# Illustrated Parts List - IPL Update

**H562XP/XPG**

## 1. Filter holder

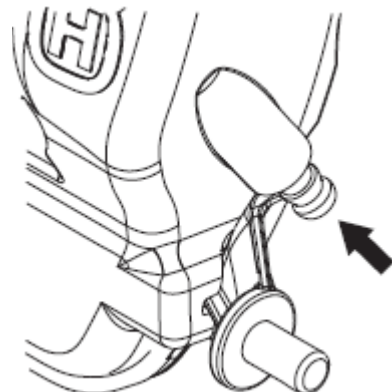
1. A new Filter holder, assy: 525 39 79-05 (standard) has been introduced. No nipple, hole removed to improve the startability.  
The same change has been made on Filter holder, assy: 525 39 79-06 (heat).
2. A new Hose kit 589 35 71-01 replace the Hose 587 64 54-02. The new kit can be used for both new and old models regardless of which generation of filter holder the user have.
3. A new Hose 587 64 54-04 added for the new filter holders without nipple.
